Inland Rail TSR Report

The following is a report of the Inland Rail TSR (Travelling Stock Route) options for the Arrow Site at Narrabri, NSW. In conjunction with the LLS during a site visit on the 26th March 2025 multiple options for the amendment of the TSR along, and under, the Newell Highway at the Arrow site were proposed and discussed. I will provide my assessment on the suitability and recommendations of each option discussed on the day with the aim of encouraging a suitable and safe outcome for both Inland Rail and LSS, as well as the stock and stockmen who utilise the TSR.

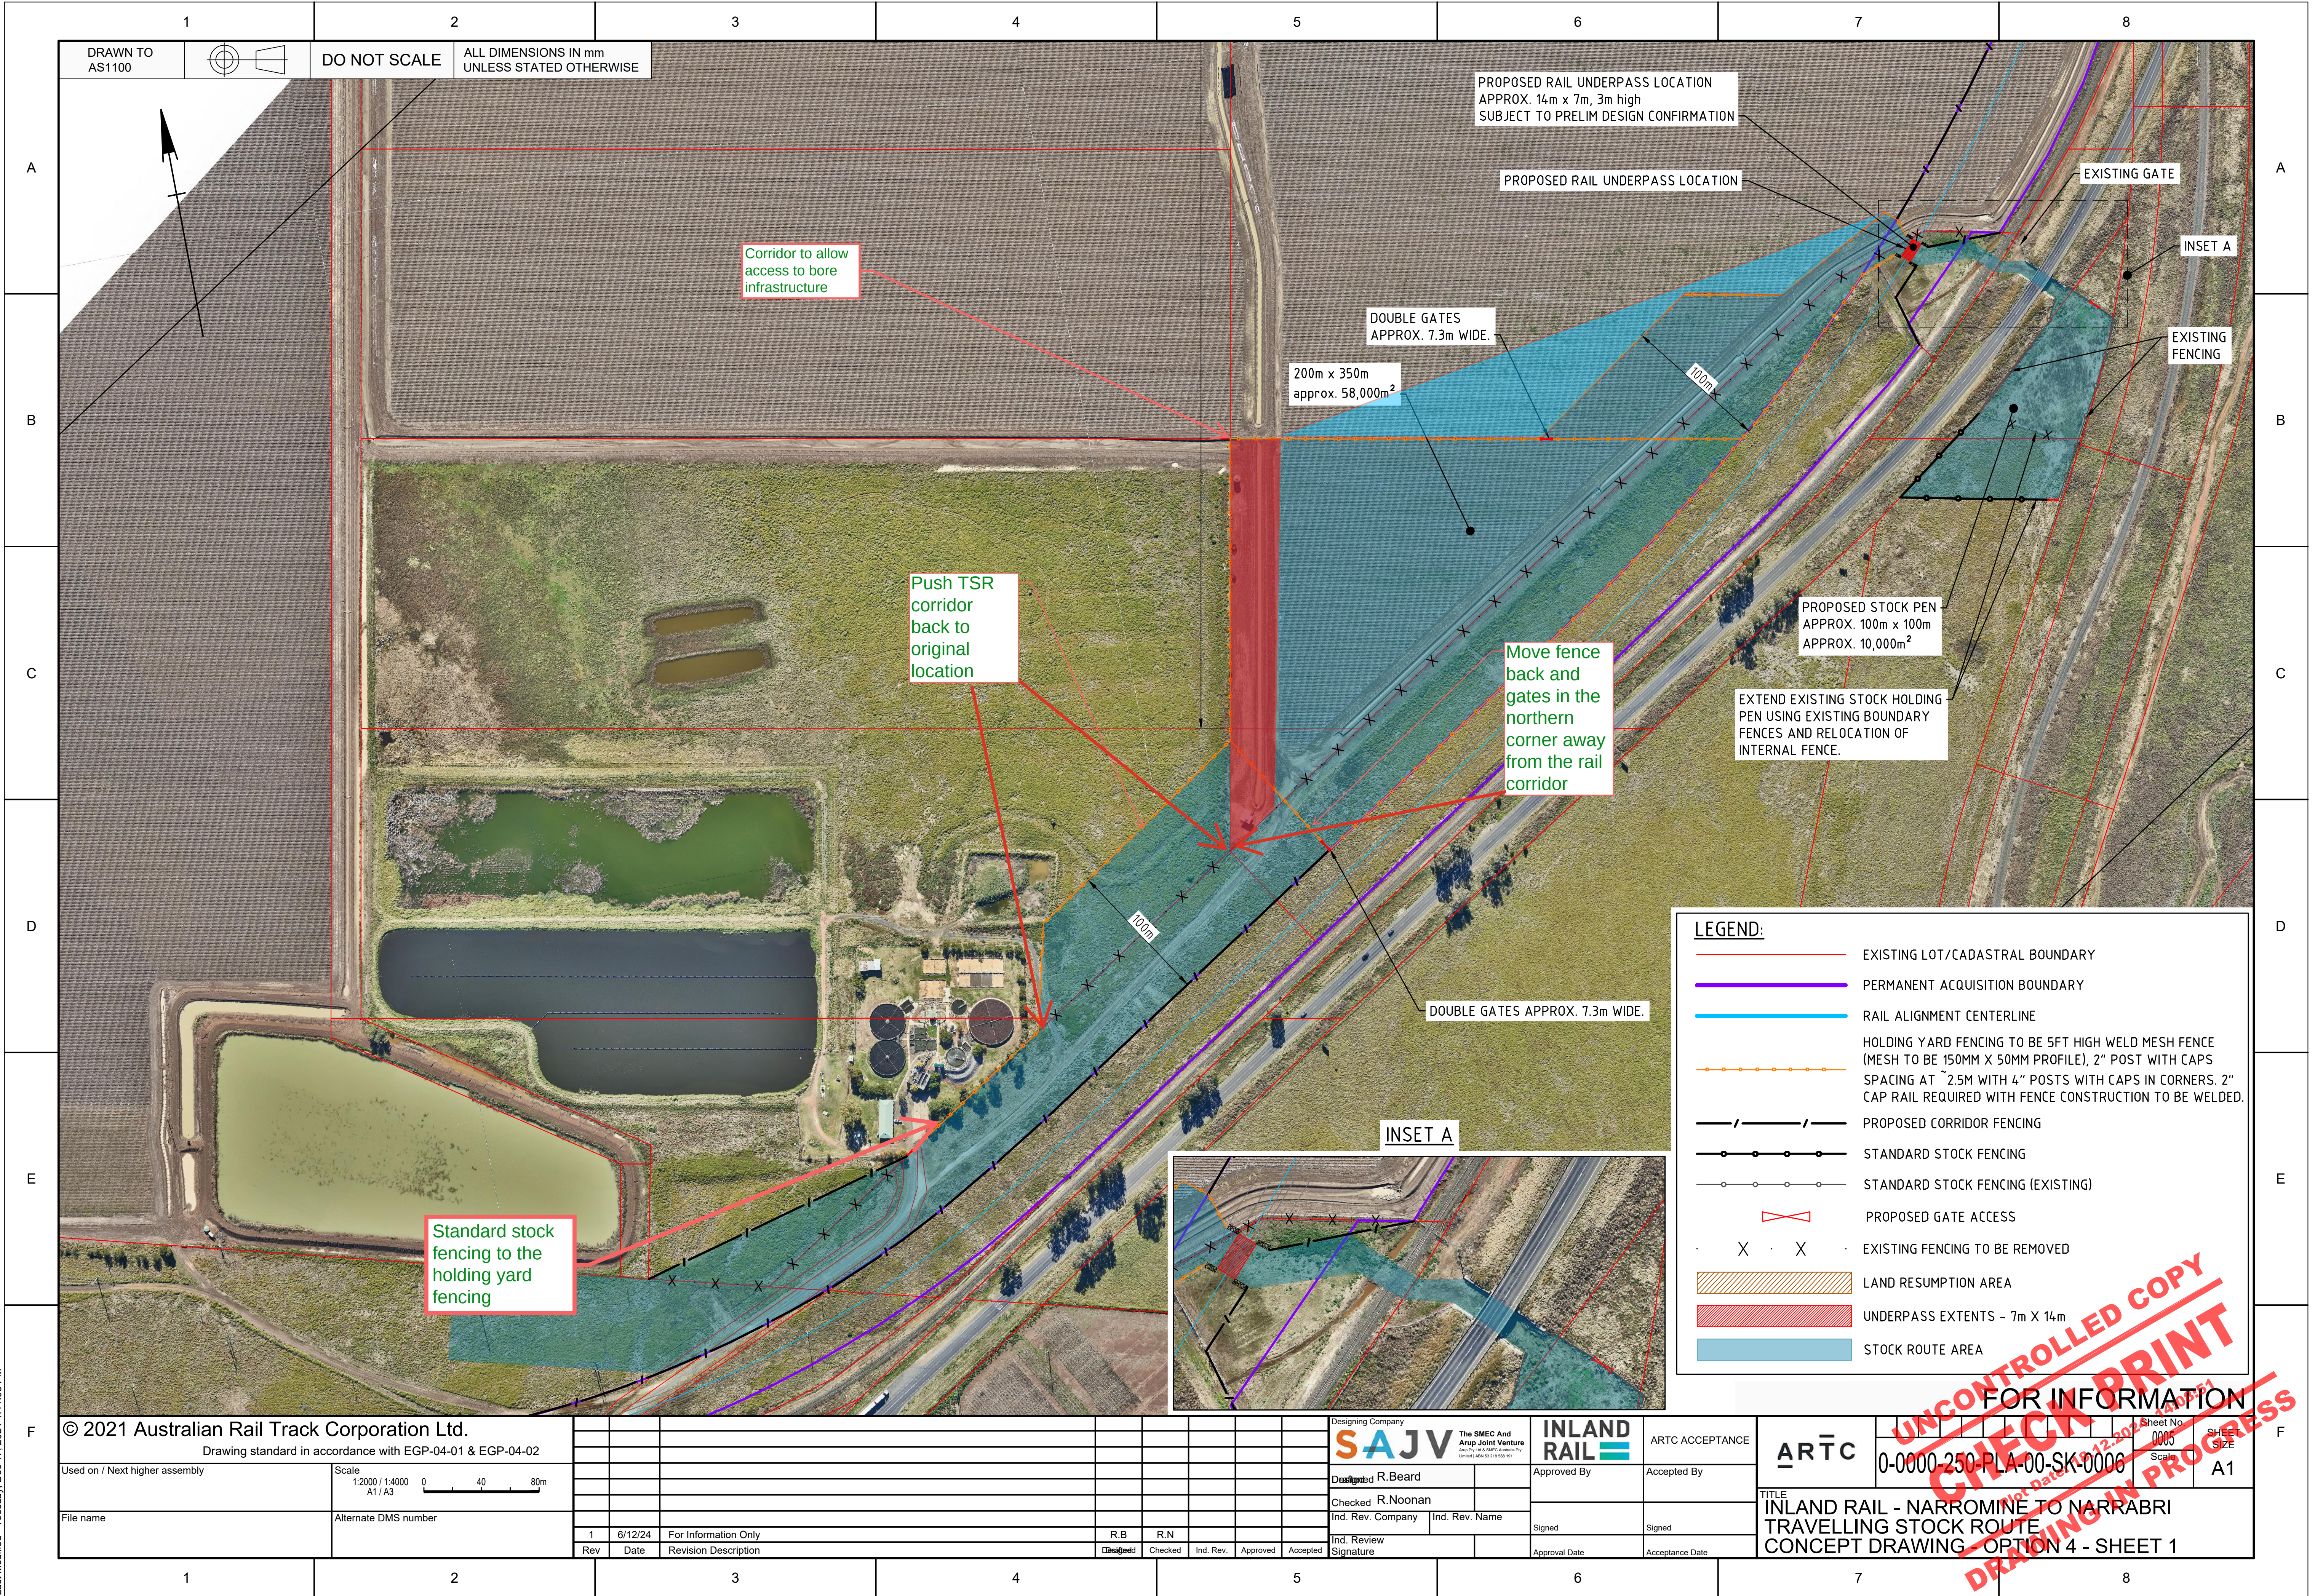
Option 1: TSR is left as is, with the proposed Inland Rail track to consume a portion of the TSR as it approaches the underpass.

Overview: Not recommended. Intensity of stimulus too high without ability of cattle to behaviourally adjust the intensity. Width will reduce flow and potentially increase frequency of exposure. More likely to result in flight behavioural responses.

My opinion is that this option is not feasible as the proposed rail line impacts the TSR to an unacceptable level close to the underpass creating not only an undesirable junction of the TSR as it veers under the Newell Highway, but also narrows the existing TSR to an unacceptable width, increasing the intensity of every exposure to the stimulus without a chance of escape. This narrowing would create a bottleneck of sorts as stock turn to pass over the existing railway, but also increase the amount of time stock are in close proximity to the rail line by limiting stock movement simply based on flow. This, in my opinion, is more likely to induce a flight or panic response in the cattle in a confined space, increasing the chances of injury or breaking containment.

Option 2: East-West Corridor crossing the Newell Highway at the Arrow Site

Overview: Feasible. Reduced intensity and duration of potential stimulus exposure. Higher public safety risk owing to more artificial substrate changes which may increase baulking behaviours.

Behavioural concerns for this option include multiple changes in substrate which can be minimised by creating a somewhat continuous substrate (asphalt for example) that will reduce baulking by maintaining colour and light/dark continuity for the cattle from the holding pen on the Western side to the holding pen on the Eastern side of the crossing. Baulking increases the chances of cattle pushing at peripheries of the crossing and breaking containment, escaping up the existing rail line, or onto the Newell Highway where they can pose a risk to the public.

Option 4: Utilising the current TSI with land acquisition additions to facilitate increasing width and holding capacity of the current TSI.

Overview: Most Feasible. Ability to utilise existing TSR. Reduced intensity of exposure, retained duration and frequency of exposure. Ability to behaviourally withdraw from stimulus.

My opinion is that this option is also feasible, and poses a lesser public safety risk than Option 2. By widening the corridor for the majority of the increased proximity area (approximately 1km TSR directly adjacent to the Proposed Rail Line) we can reduce the intensity of the stimulus and allow the cattle room to behaviourally respond (move away). In addition, a wider corridor also increases flow and reduces the time for mobs to travel the corridor, potentially reducing the frequency of exposures. It is my recommendation that this corridor be fenced with 8-10ft fencing with blackout matting to reduce visual stimuli for any area within 50m of cattle flow. There is one area of narrowing of the corridor, adjacent to the Water Treatment Works which is approximately 150m in length. While this is unfortunate, I feel that it is manageable as long as the visual perceived threat is reduced.

The Proposed Rail line will include an underpass at the northern end of the corridor. As cattle do not willingly turn blind corners, it is my recommendation that the underpass be matched in size and position to the existing underpass (Newell Highway) to facilitate a continuous line of sight for the cattle to encourage cattle movement. Light and shadow from the underpass(es) cannot be amended, but should be noted that cattle will have many changes of substrate and pattern for this crossing (underpass-grass-existing rail line-grass-underpass-grass) which may reduce flow and create congestion, increasing the chances of encountering a train as they move from the western side of the Newell Highway to the eastern side of the Newell Highway.

Additionally, as cattle will not willingly move towards an aversive stimulus (visual or auditory), and in line with my recommendations that any rail within 50m of cattle movement be visually shielded up to 10ft, I also recommend the overpass be visually shielded. This should also reduce the auditory stimulus intensity. The risk of baulk, or flight behaviours in cattle should a train suddenly appear on the rail above them may result in the mob splitting to avoid the train stimulus, which as discussed can result in mixing of mobs, mismothering, increased agonistic behaviours and stress. This is not a major concern for the Newell Highway underpass as the road is set further back from the edge of the underpass, and the height also means that cattle cannot easily view the road traffic as they approach. As the Rail Line will be narrower, the trains will be easily visible to the cattle as they approach if they are not shielded (as a function of line of sight).

Conversely, utilising cattle's aversion to sudden substrate changes, should this option be selected it would be recommended that the Newell Highway crossing perimeter be demarcated with a grid pattern to encourage animals to stay within the confines of the crossing.

that at the very least yard fencing facing the Rail Line be shielded with black rubber matting to create a more insular area. It is expected that watering points will be available to cattle at these holding areas. If holding times are expected to be greater than 6 hours during the peak of the day then shade should also be provided in the form of vegetation or shade matting.

In conclusion, Option 4 is the most feasible from the standpoint of modifying existing routes to facilitate behavioural safety. Option 2 would potentially result in the least stimulus exposure but poses an increased public safety risk which may, or may not mitigate this.
